WATERBURY FILING NO. 1

FINAL PLAT

A PORTION OF SW 1/4 SECTION 28, A PORTION OF THE SE 1/4 SECTION 29, A PORTION OF THE NW 1/4 SECTION 33, TOWNSHIP 12 SOUTH, RANGE 64 WEST OF THE SIXTH PRINCIPAL MERIDIAN, EL PASO COUNTY, COLORADO

PCD FILE NO. SF23-07

SHEET NO. 1 OF 7

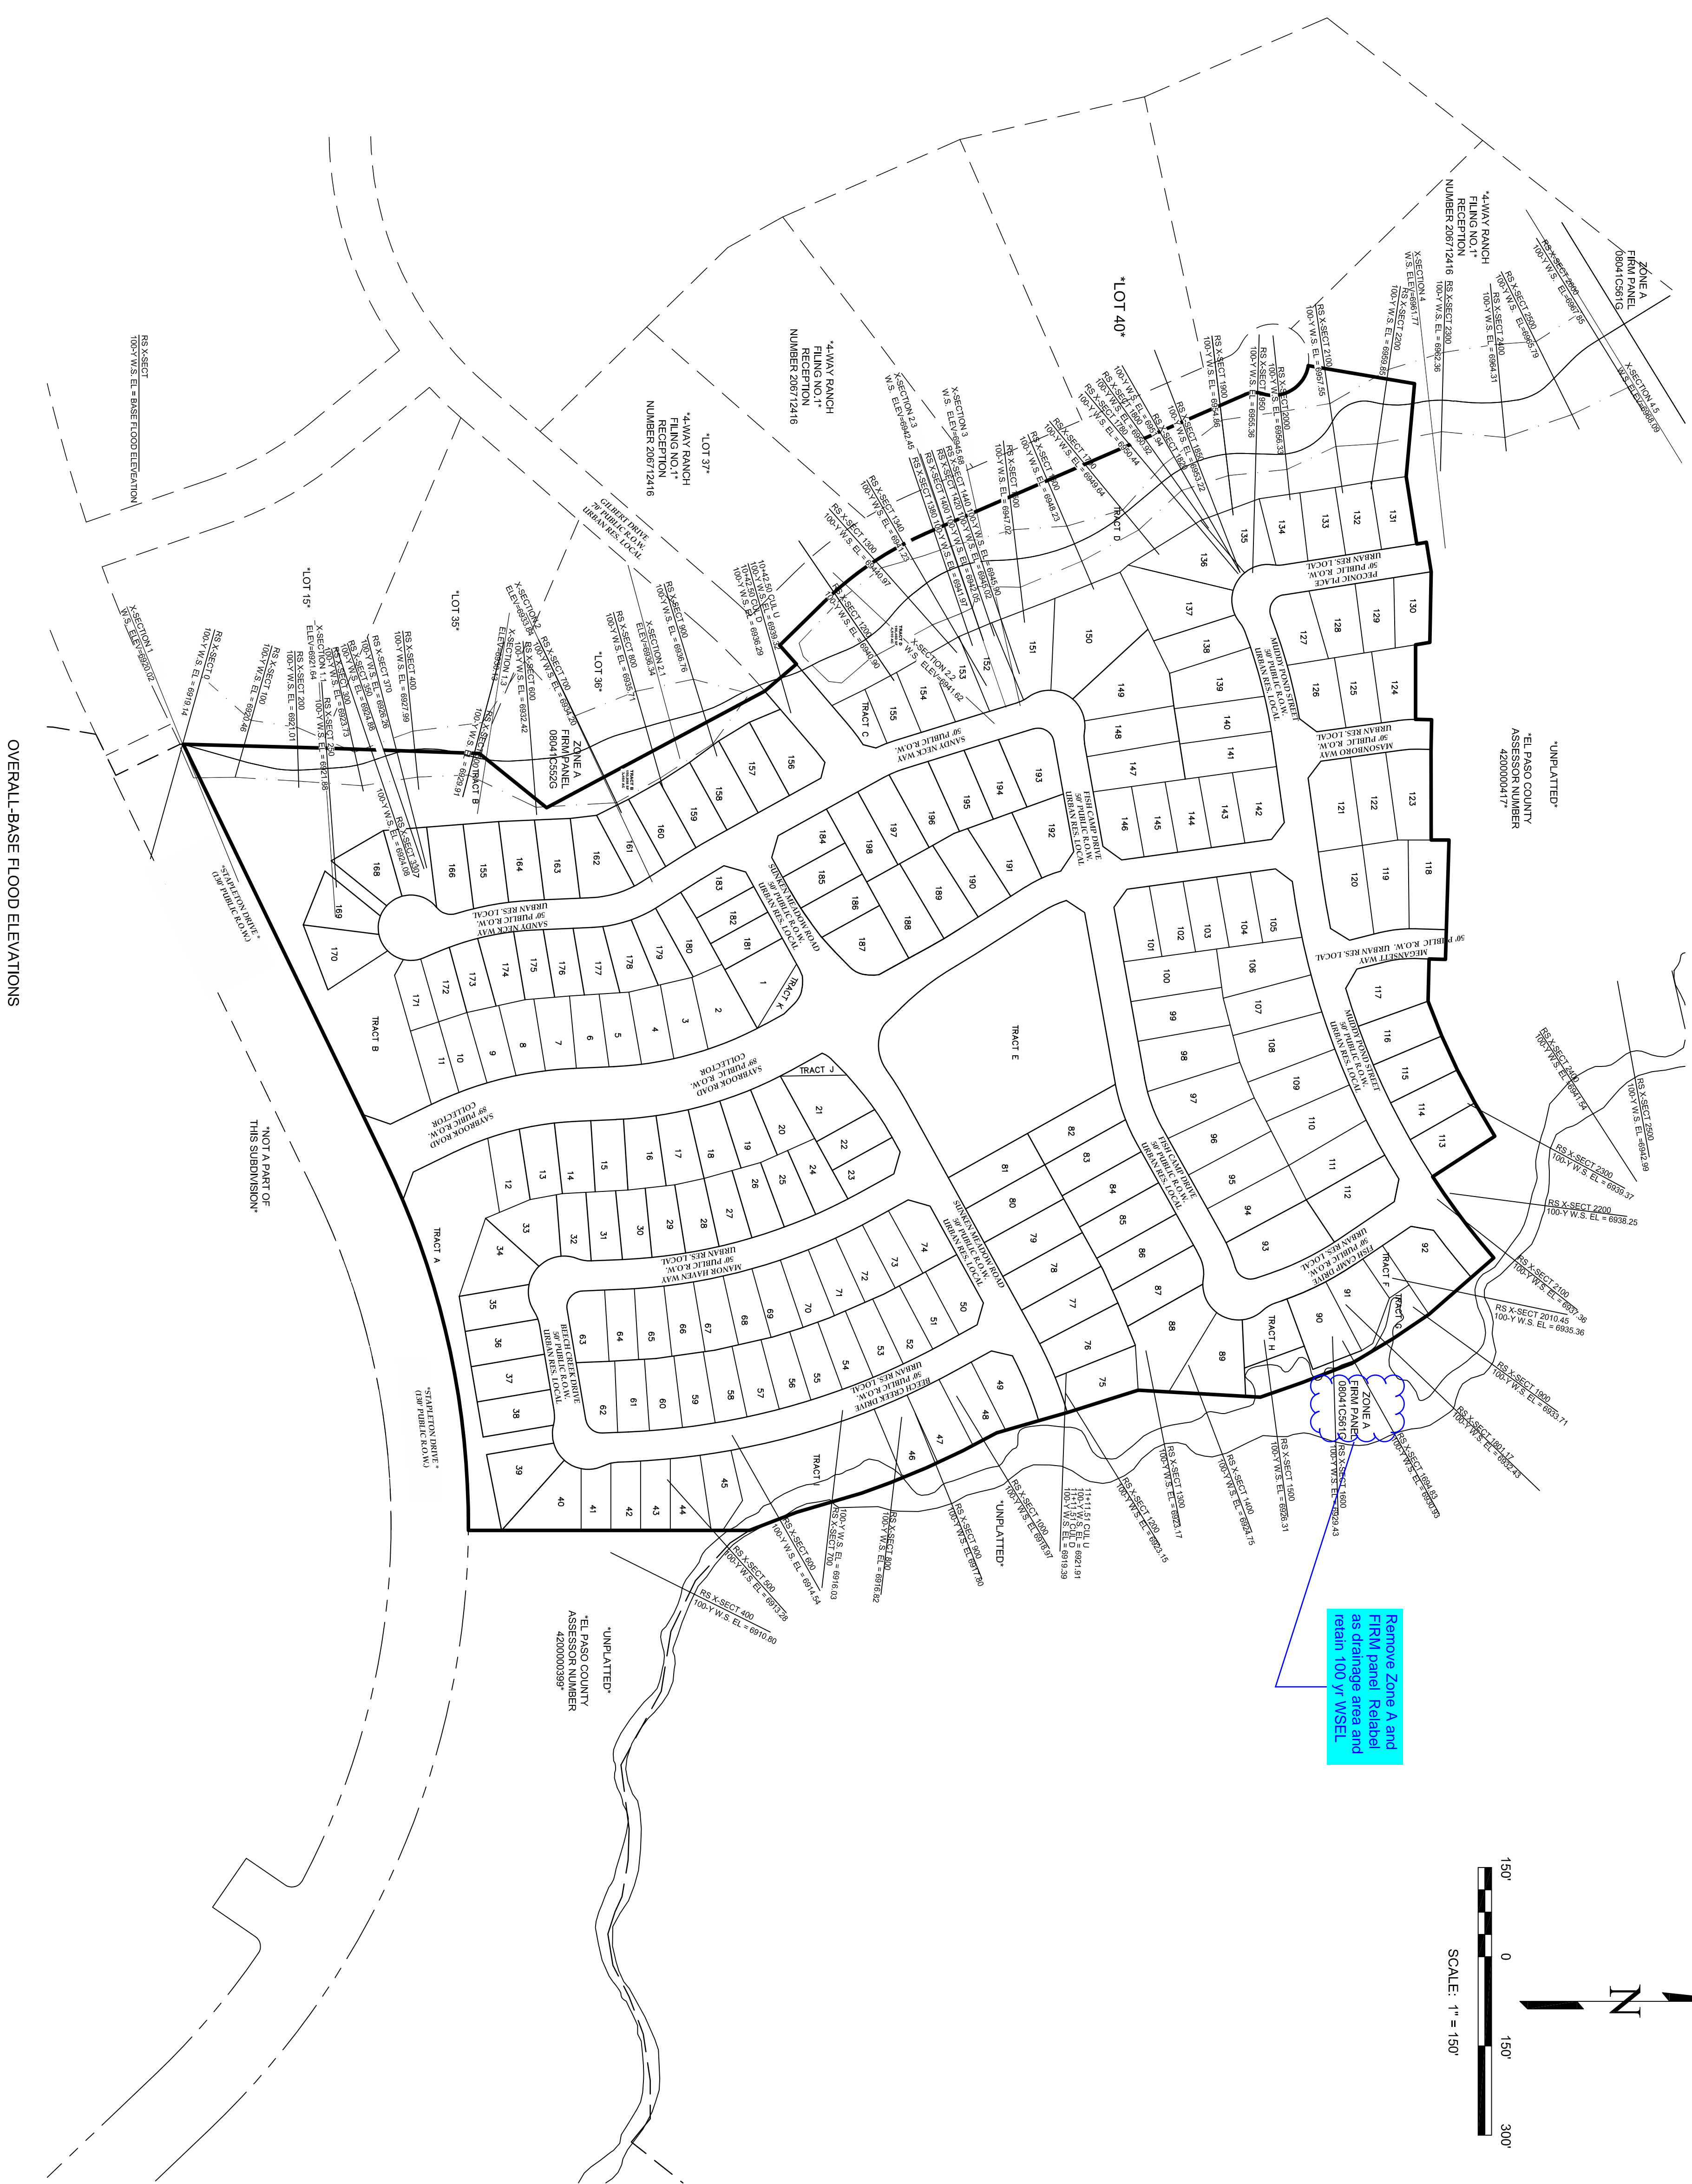
PLEASE BE AWARE that since 4-Way Ranch Metropolitan District No. 2 has changed its name to Waterbury Metropolitan District No. 1, ALL documents and agreements referencing 4-Way Ranch Metropolitan District No. 2 will need to be updated to Waterbury Metropolitan District No. 1. I made several comments on the plat regarding this, but I recommend that you double-check for all instances to ensure we do not need additional corrections on a subsequent submital.
